Product Change Notification

- Change to M8 female connector on the e-Series

Product(s) Affected: All e-Series

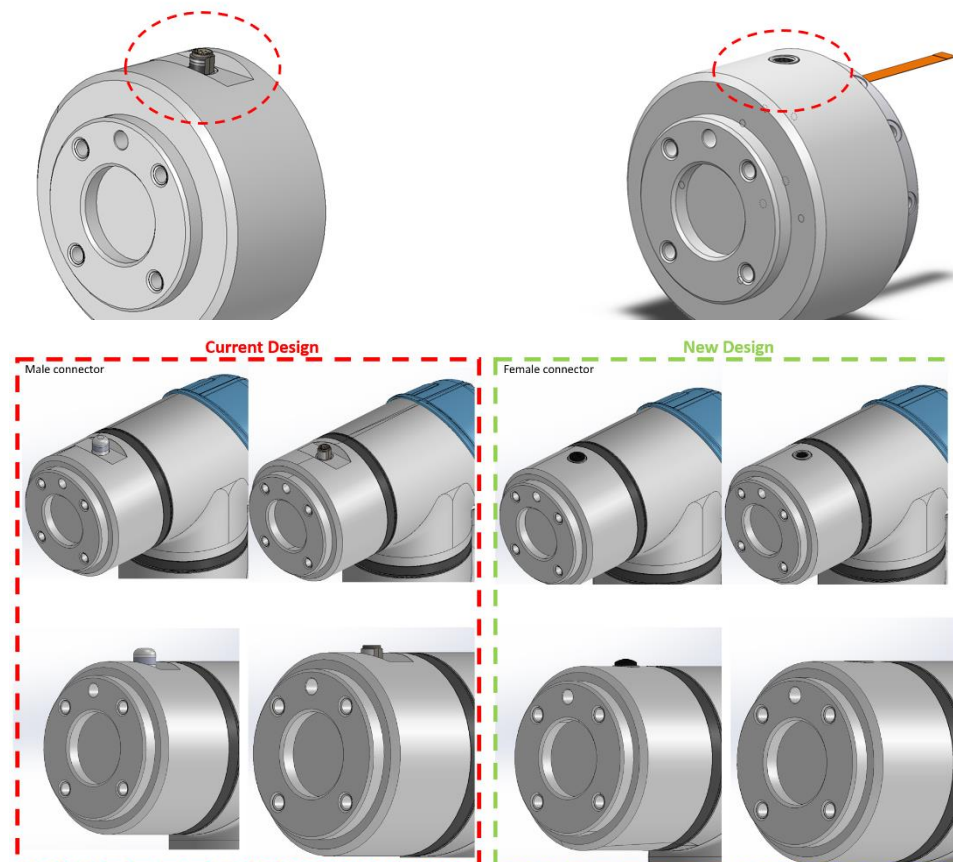
Summary: Changing the M8 connector on all e-series robots from a male version to a female version. The tool cap was also facelifted to fit with the female version.

Detailed info: The current M8 connector will be changed from a male version to a female version. The connector will be inside the tool cap as illustrated in the pictures below. We will provide an adaptor (15 cm adaptor cable, Male – Male M8) to soften the transition and enable tools with the current connector type.
